Product Change Notice (PCN)

Subject: Change Lid Supplier on Select Packages

Publication Date: 2/7/2022

Material Comparizon

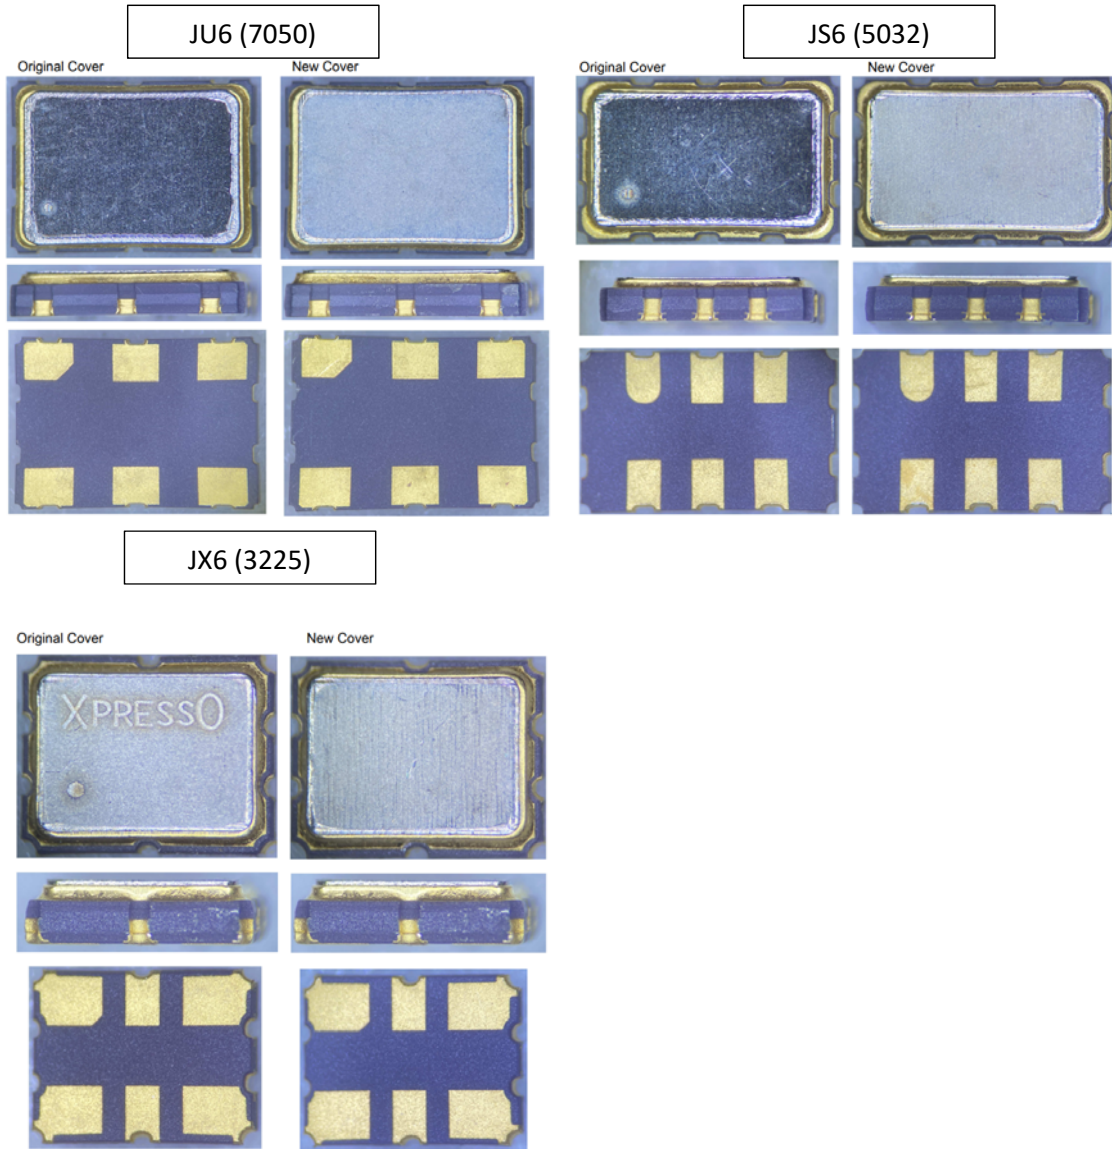
Renesas is changing to a new lid supplier, Wanotec (Japan) as a result of the current lid supplier, Kostec (Korea) will discontinue the business and the support will extend up to end of February 2022. The existing lid supplies are expect to deplete by the following dates.

The change will have no impact on the fit, function, quality, reliability and environmental compliance of the products. However, the form in specific the lid appearance is changed due to the absence of Phosphorus element in the new lid material. Refer to photos shown in page 2.
